DRAINAGE MEMO

LOT 1, SPACE VILLAGE FILING NO. 3

6809 SPACE VILLAGE AVENUE

PCD Project No. SP-17-009

EXISTING DRAINAGE BASIN MAP

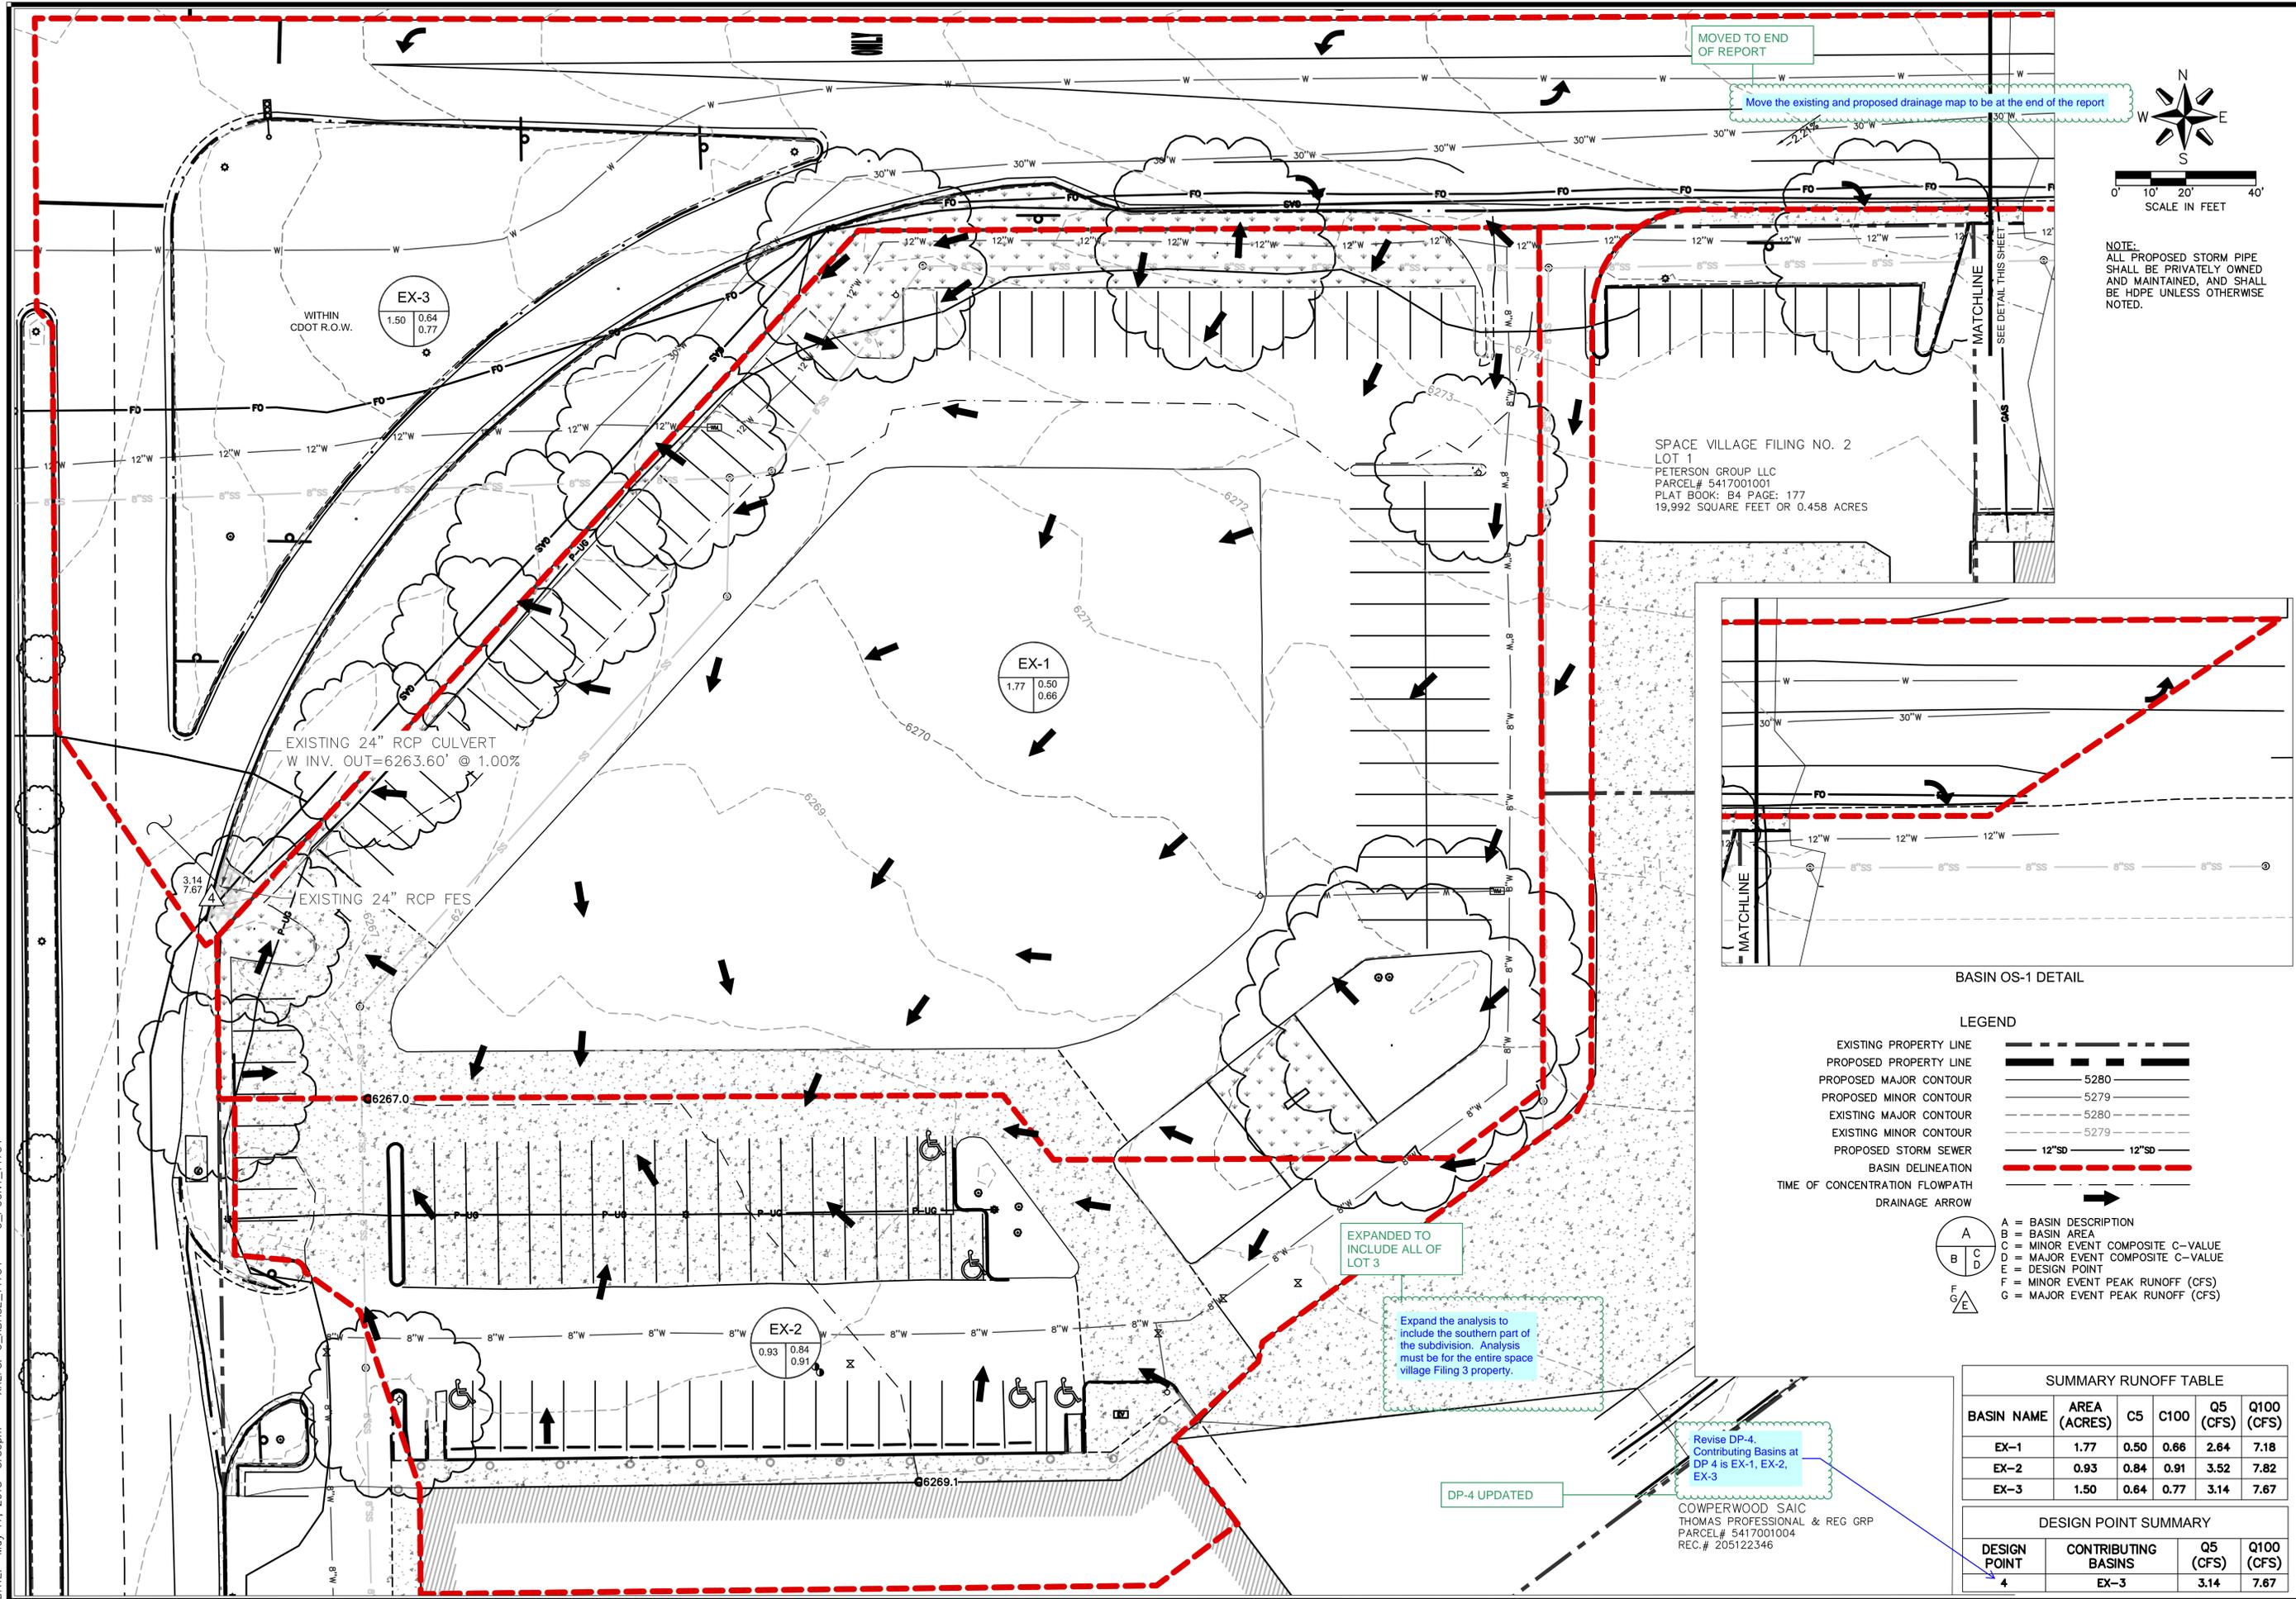
MOVED TO END OF REPORT
 Move the existing and proposed drainage map to be at the end of the report

Revise DP-4. Contributing Basins at DP 4 is EX-1, EX-2, EX-3

Expand the analysis to include the southern part of the subdivision. Analysis must be for the entire space village Filing 3 property.

SPACE VILLAGE FILING NO. 3
 SPACE VILLAGE AVENUE AND PETERSON BOULEVARD
PROPOSED DRAINAGE BASIN MAP

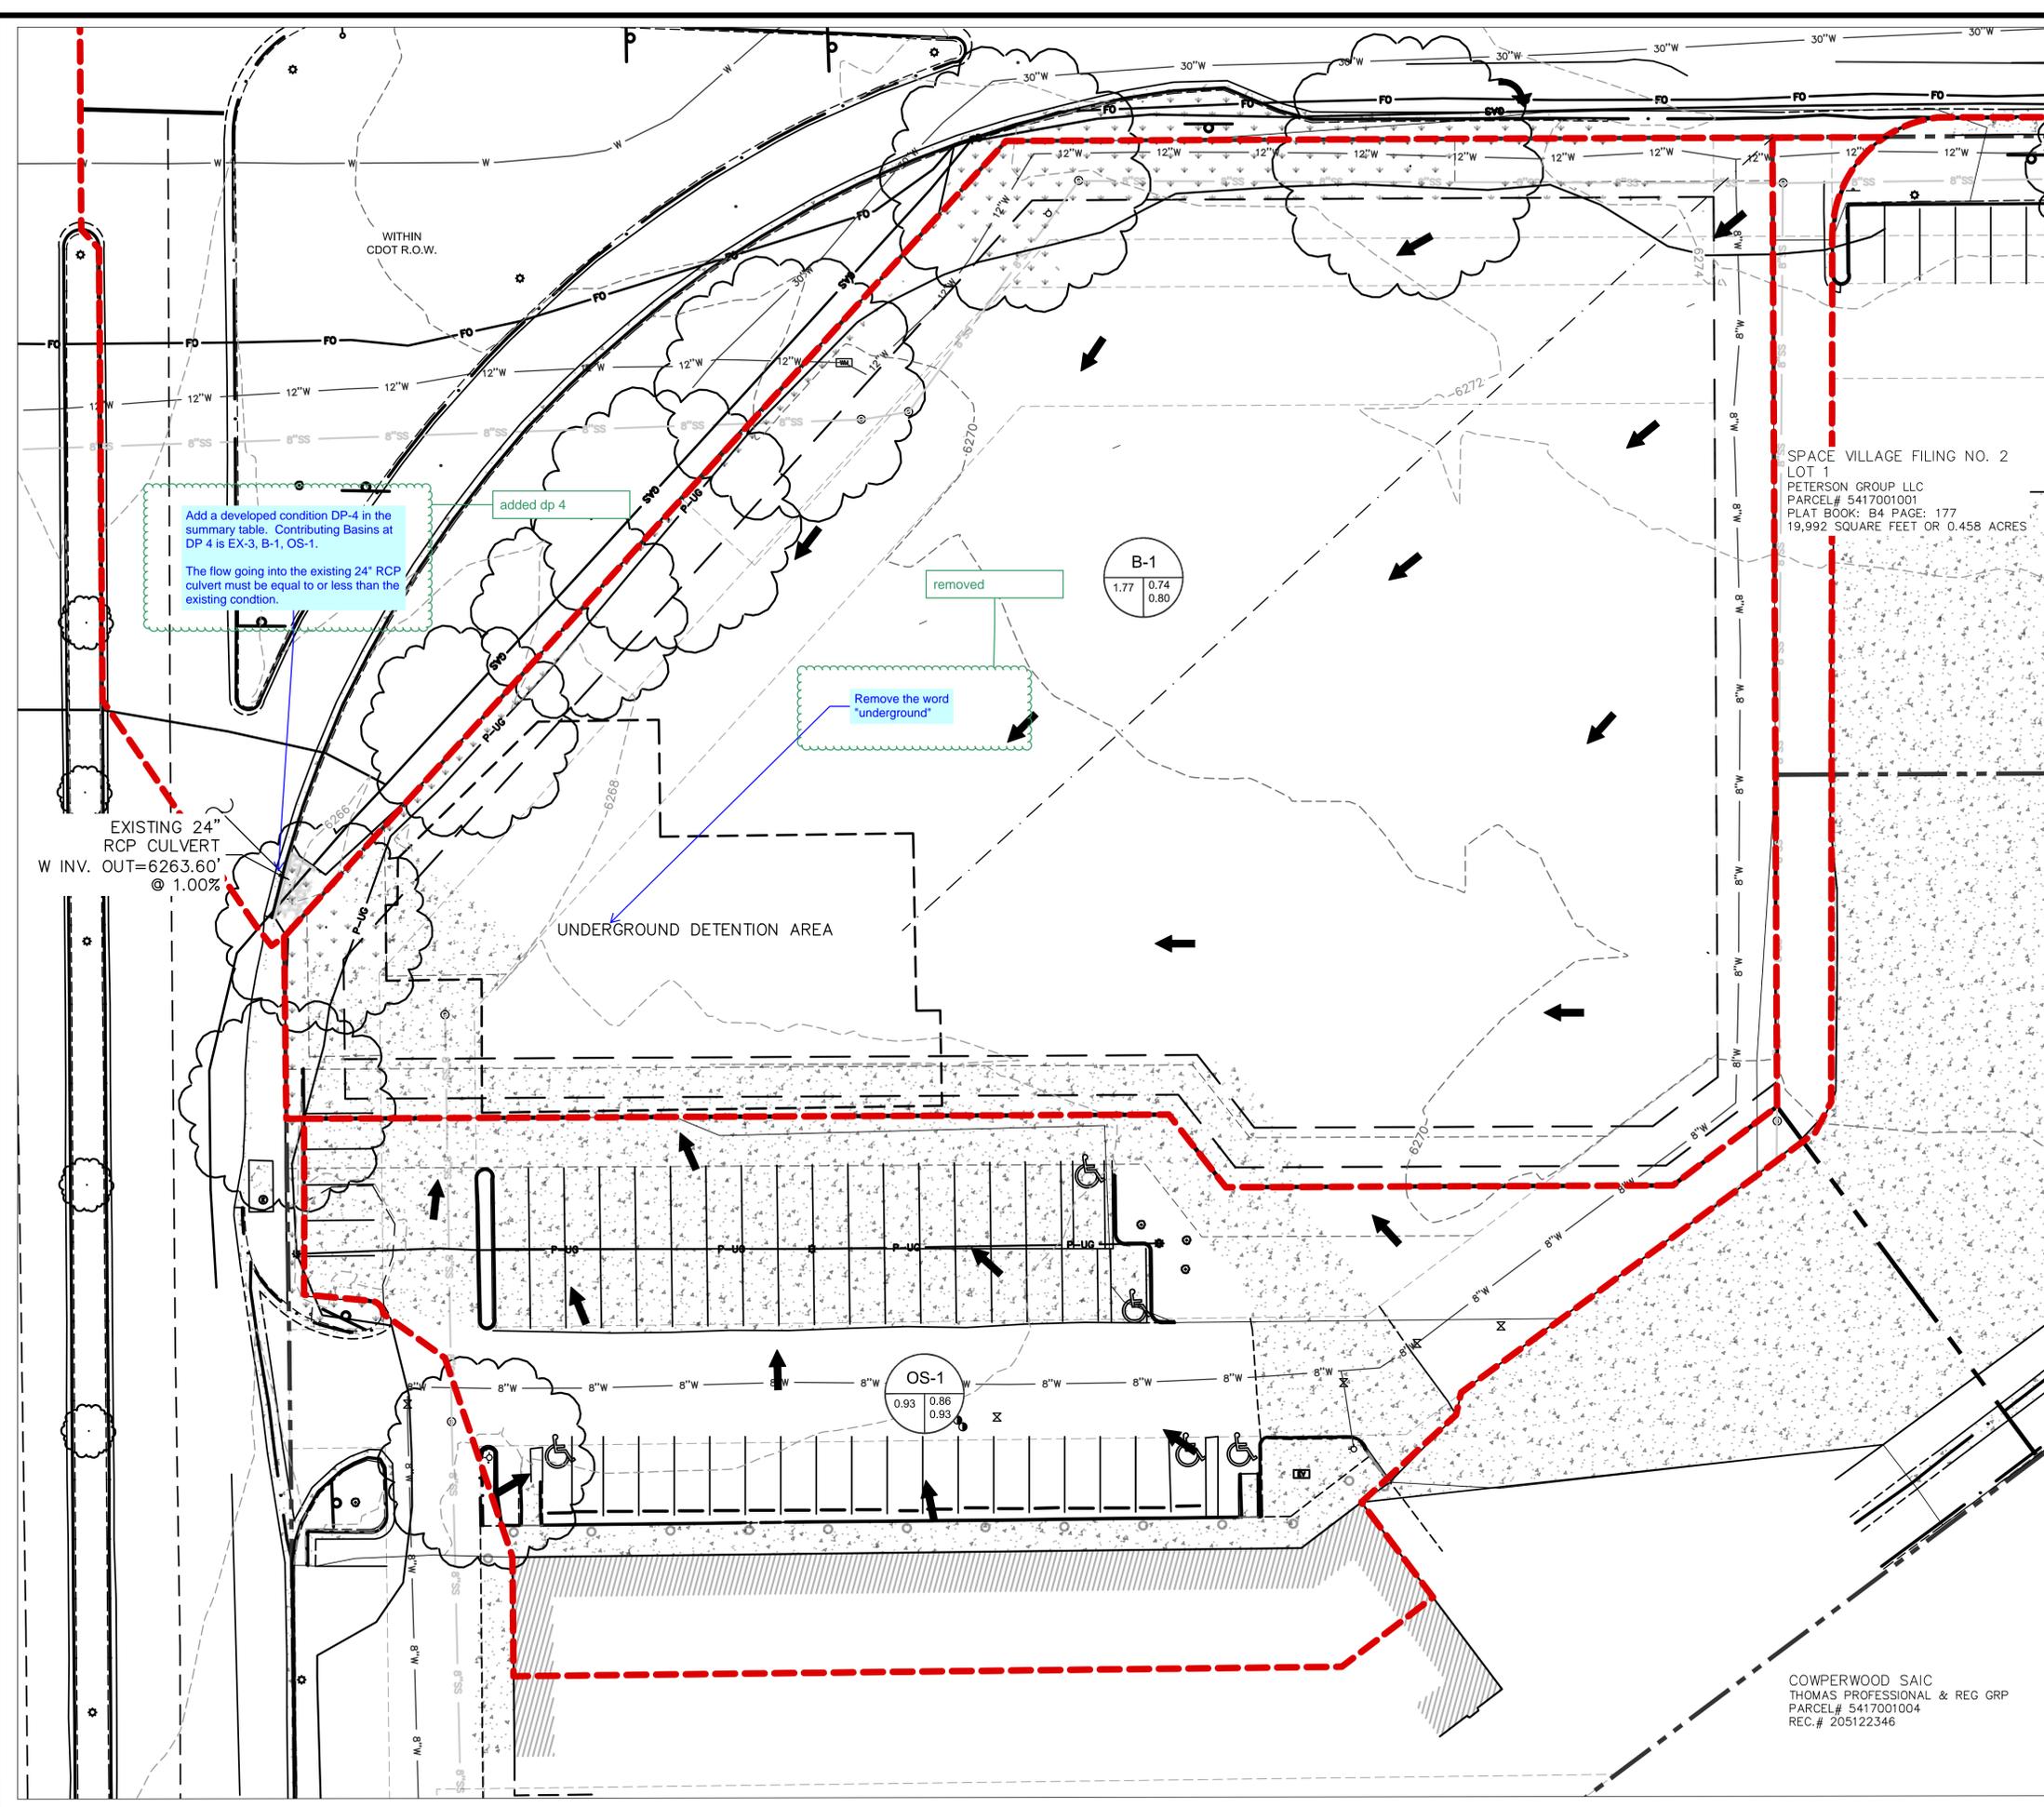
Remove the word "underground"

Add a developed condition DP-4 in the summary table. Contributing Basins at DP 4 is EX-3, B-1, OS-1.

The flow going into the existing 24" RCP culvert must be equal to or less than the existing condition.
